Bradley Heights Apartments

A 236-Unit Apartment Development Puyallup, Washington

Bradley Heights SS LLC

2-BED UNIT NON-ACCESSIBLE
2nd LEVEL FLOOR PLAN
1/4" = 1'-0"

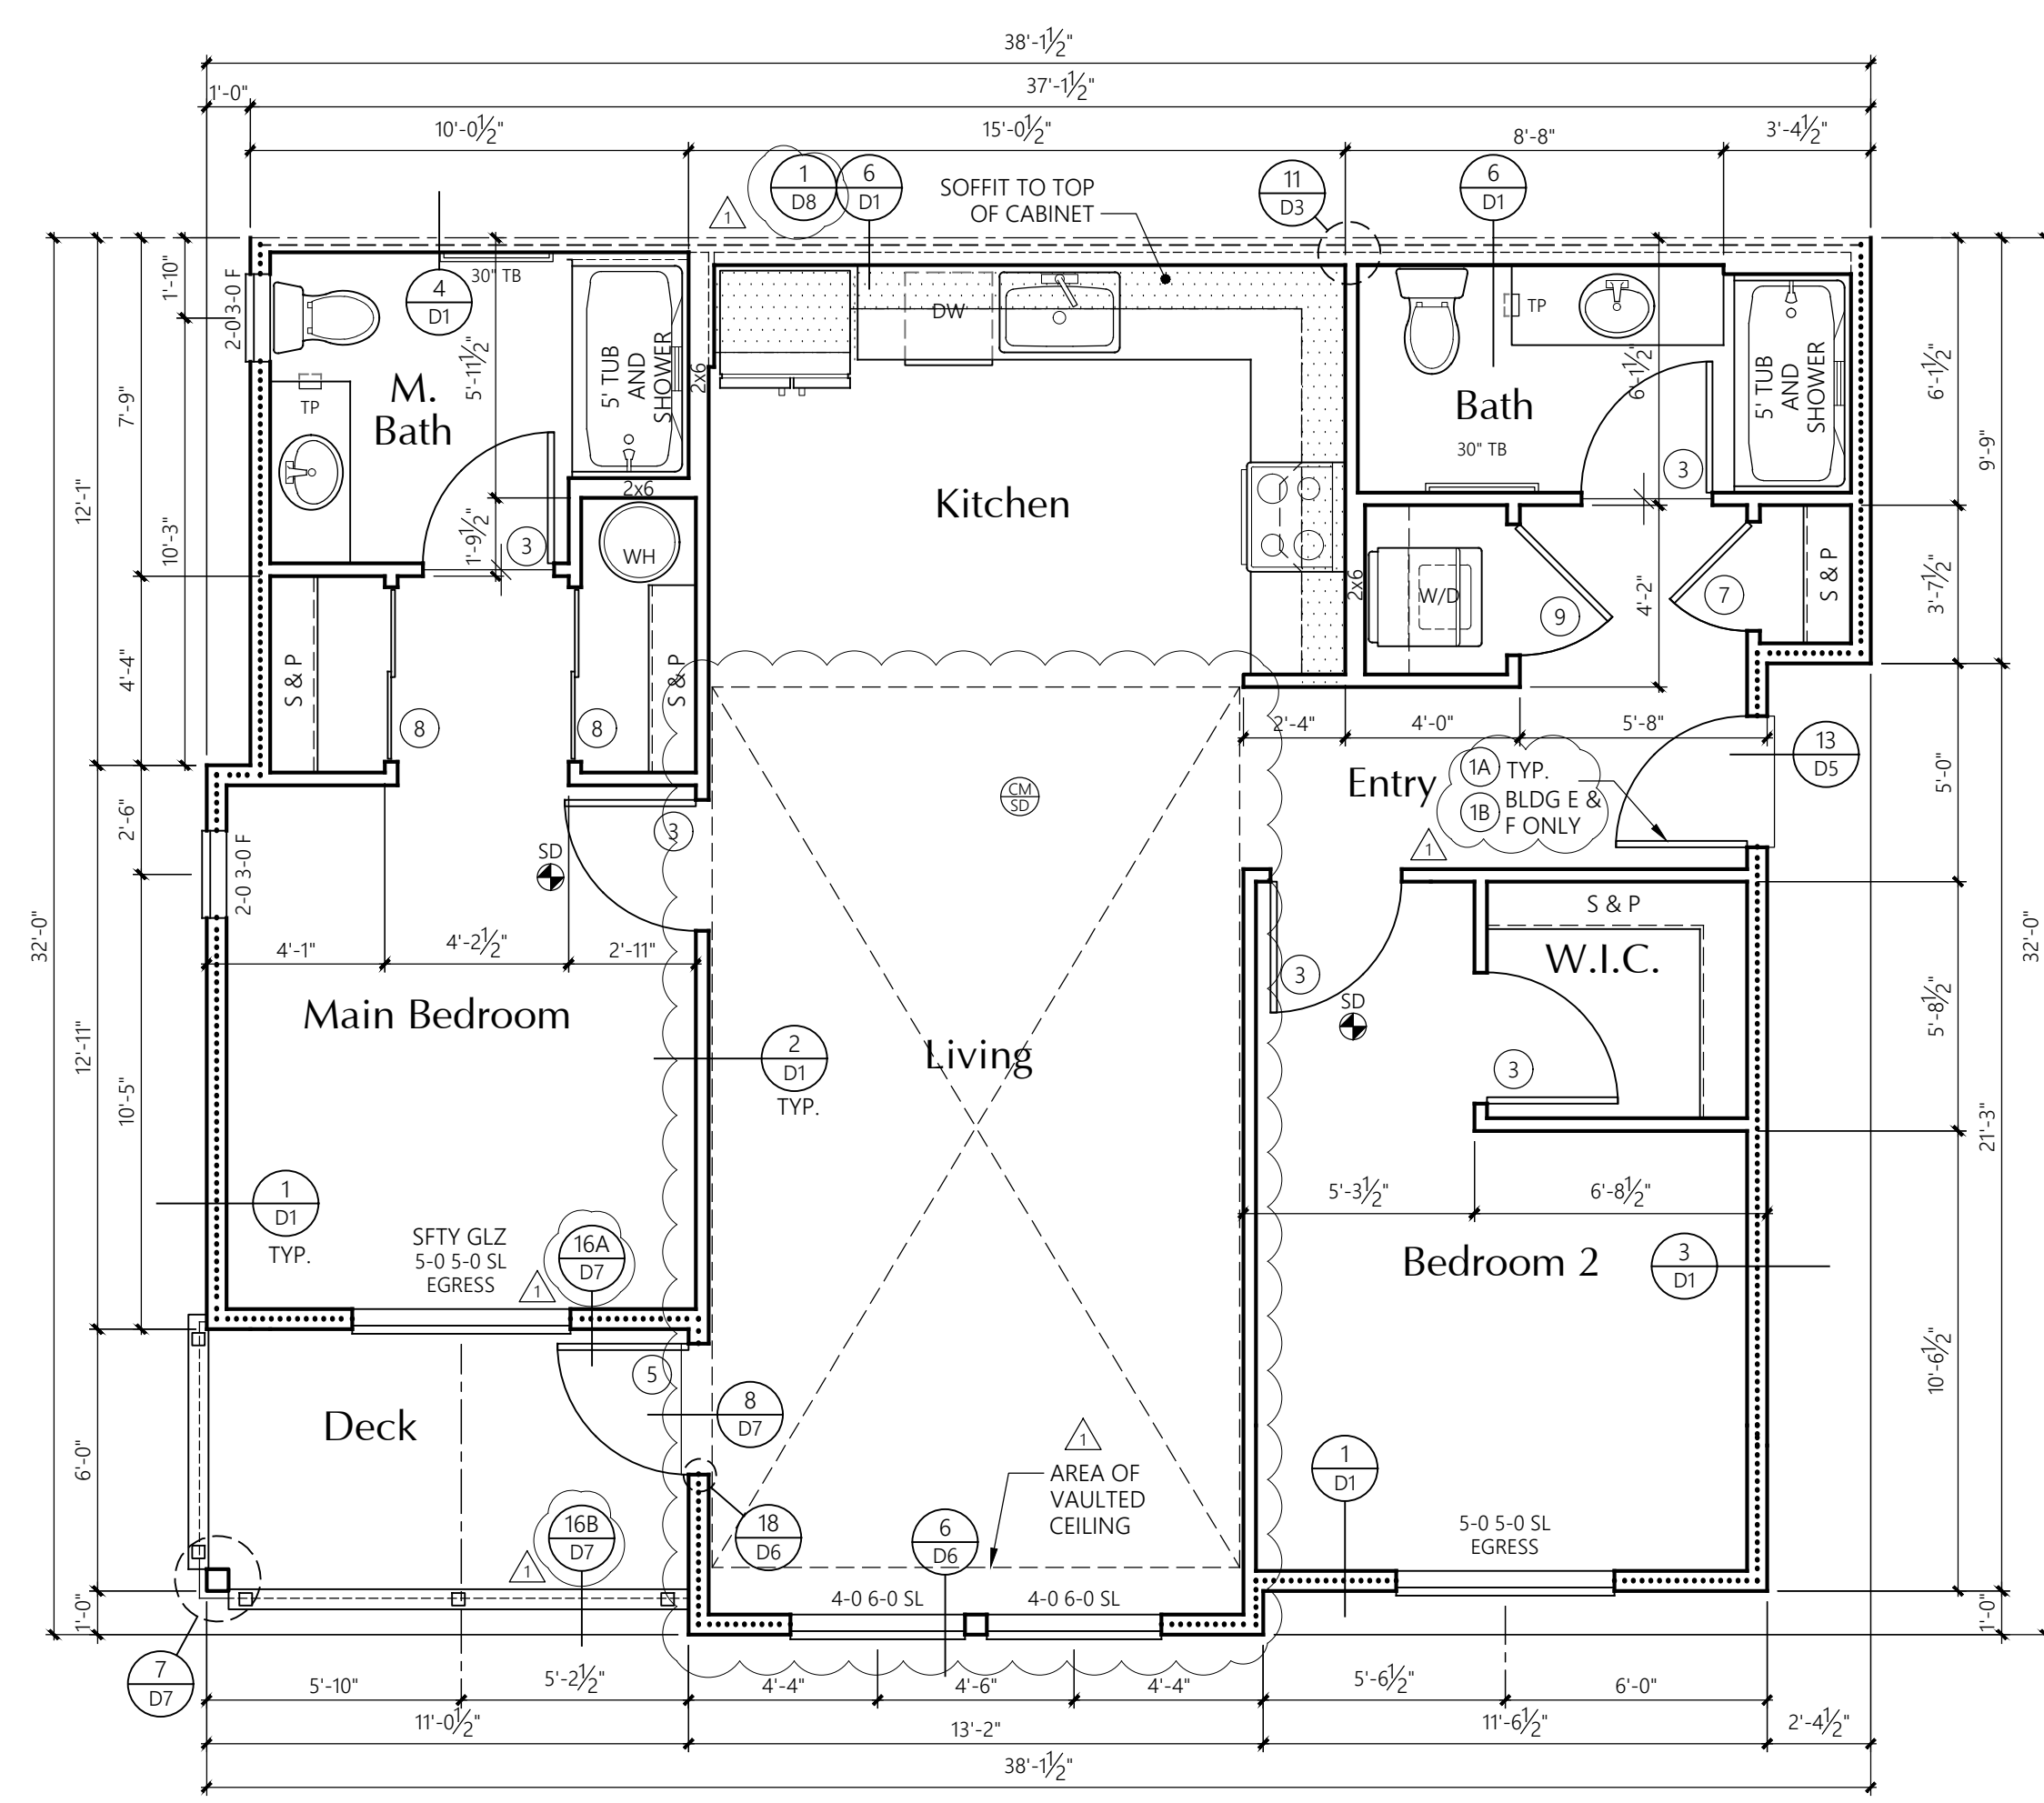
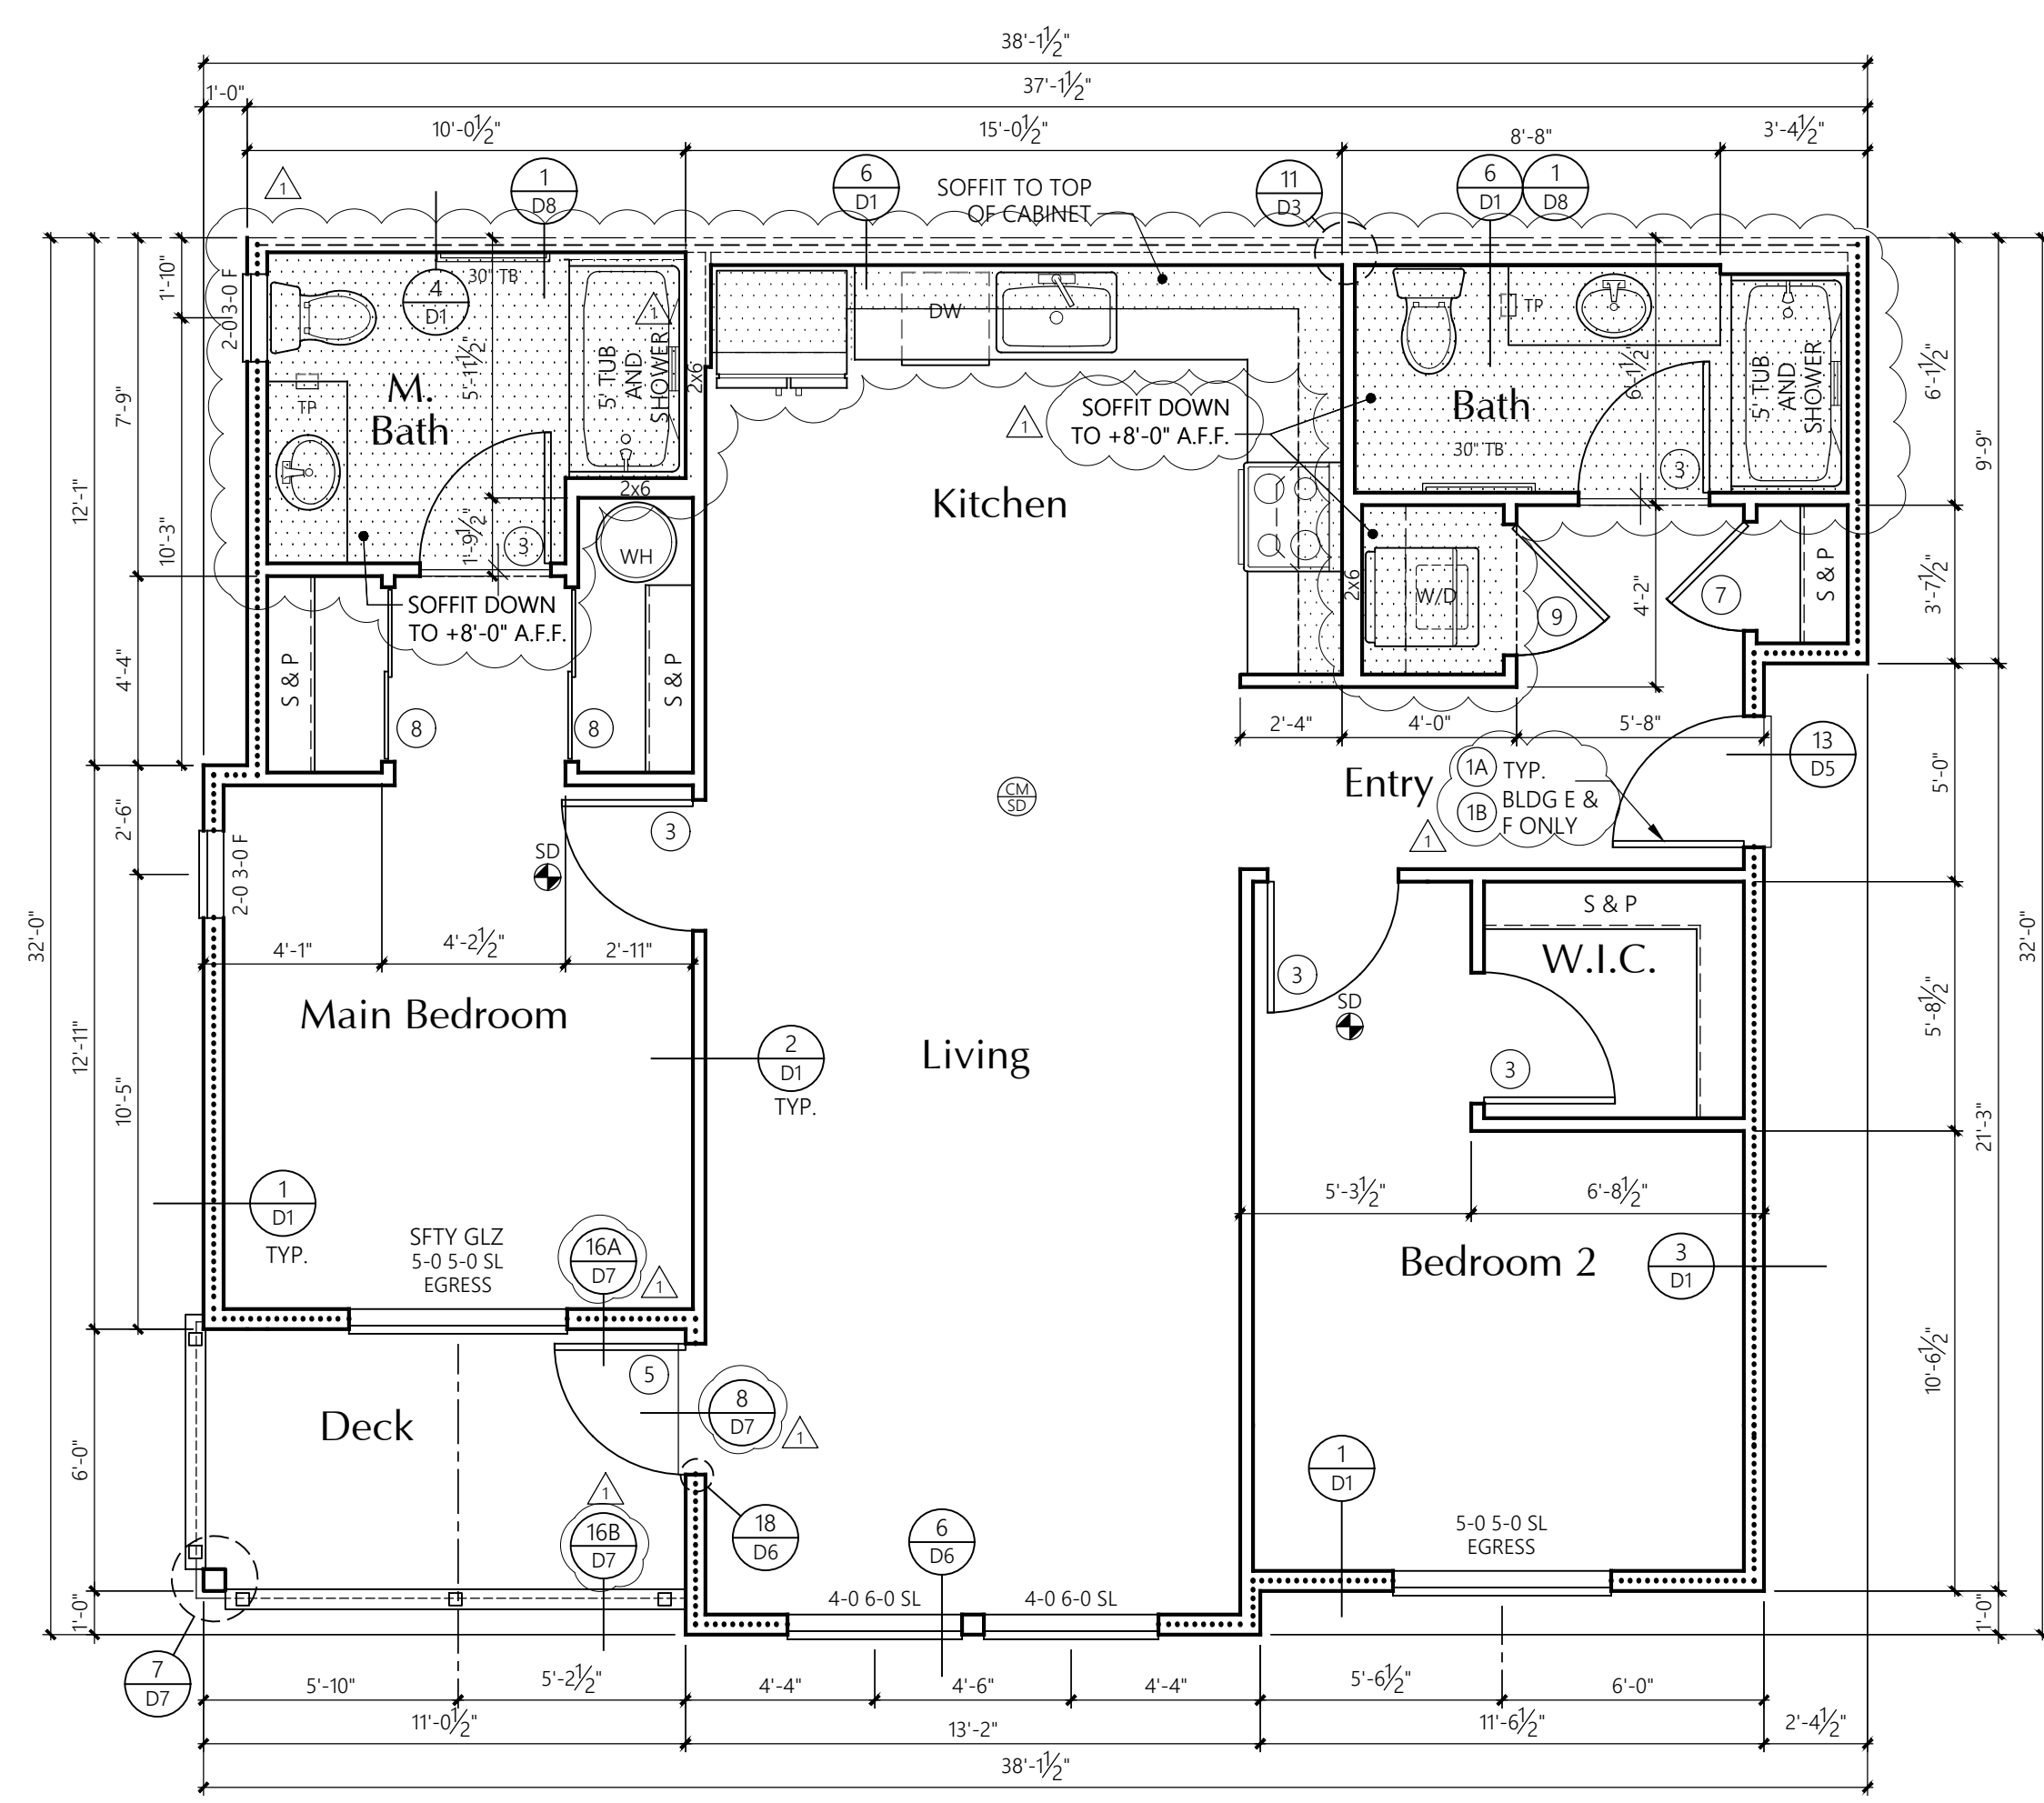
Review and clarify instances where header height will change as the header height is called out as 8" U.N.O. in Unit Plan Notes. Example 2 Bed Unit on Sheet U4 has a furred down ceiling. Review other units for additional instances and adjust if necessary.
(Construction Set, Sheet U1-U5.1, Unit Plan Notes)

Review and clarify how washer and dryer in all Type A units shall meet Washington Accessibility Code 2009, Section 611. Example 2 Bed Unit shows a washer and dryer that appear to be stackable which could put the loading openings outside the perimeters set by 611.4. Review and updated as needed.
(Construction Set, Sheet U1-U6, Unit Plan Plans)

17 ROOF AND VALLEY INSTALLATION
NO SCALE

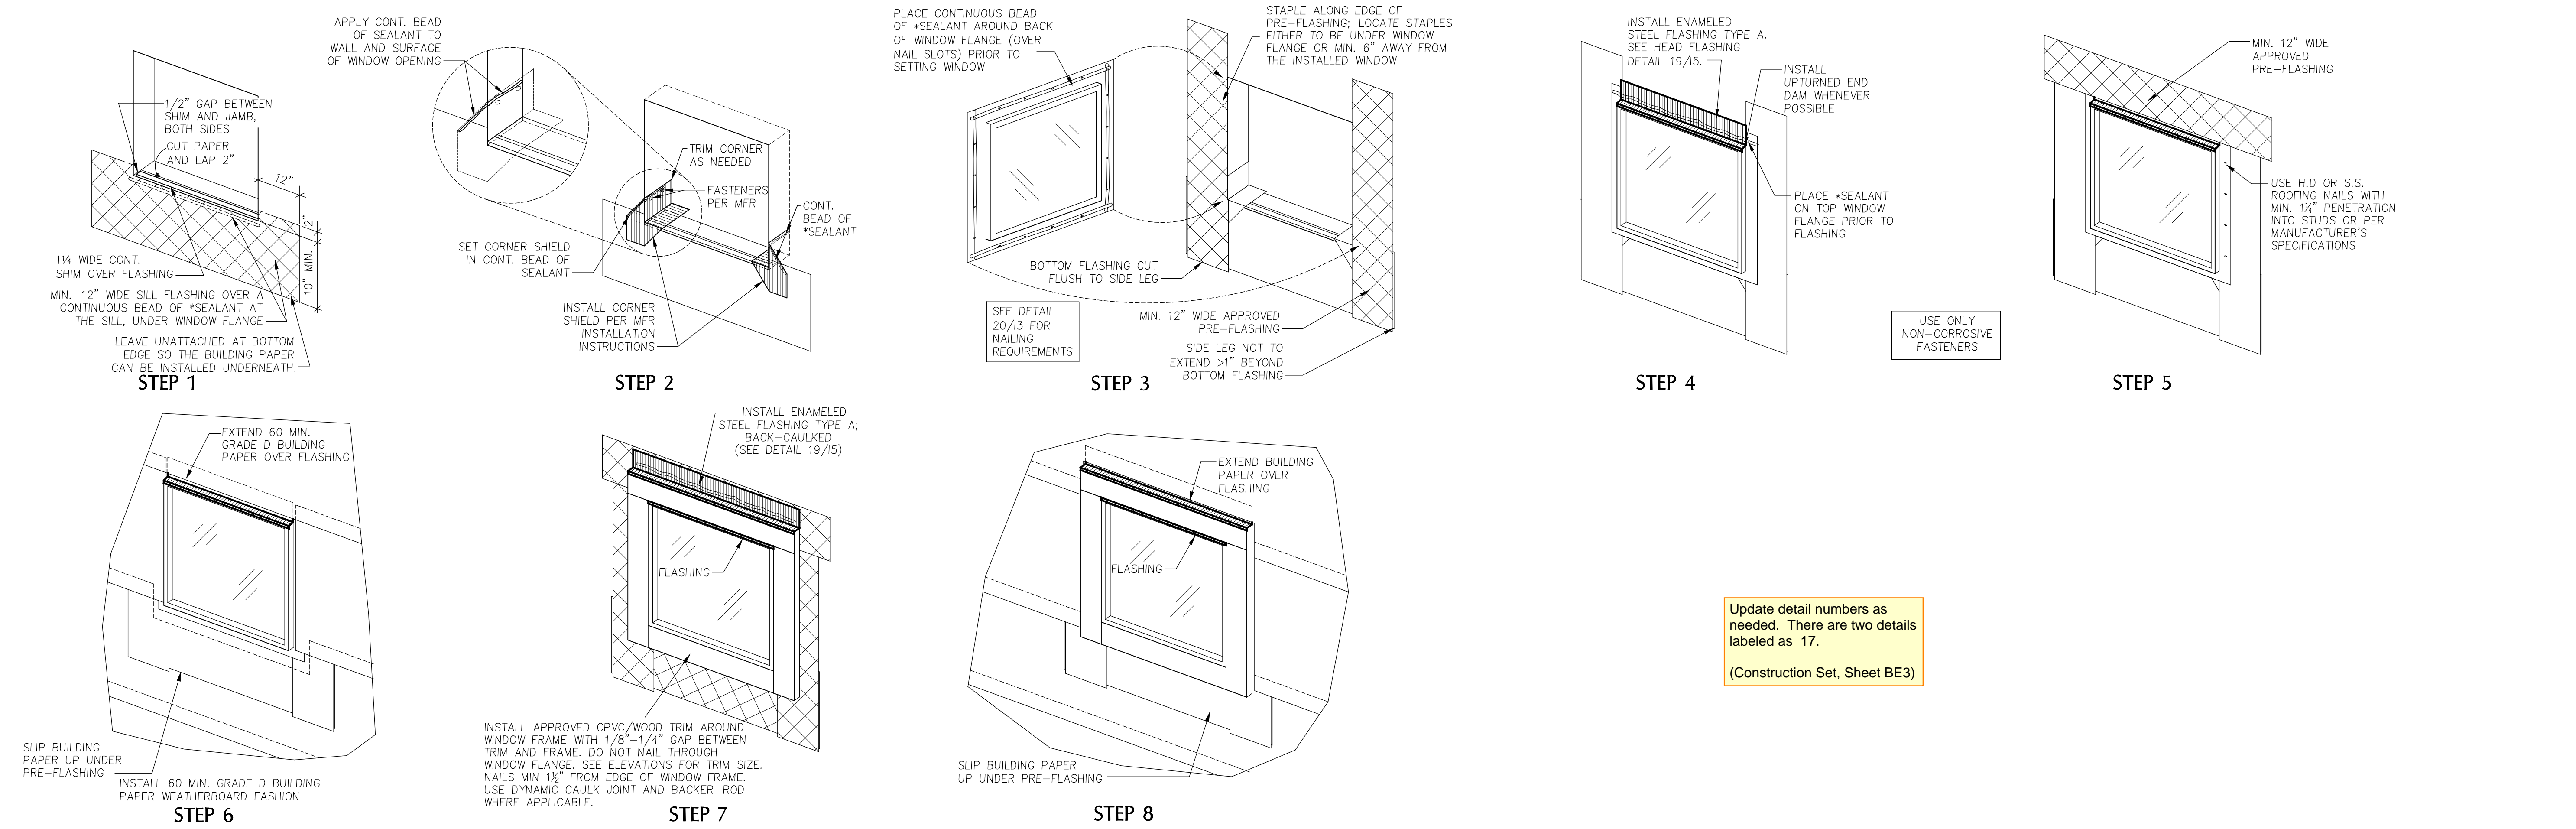
Update detail numbers as needed. There are two details labeled as 17.
(Construction Set, Sheet BE3)
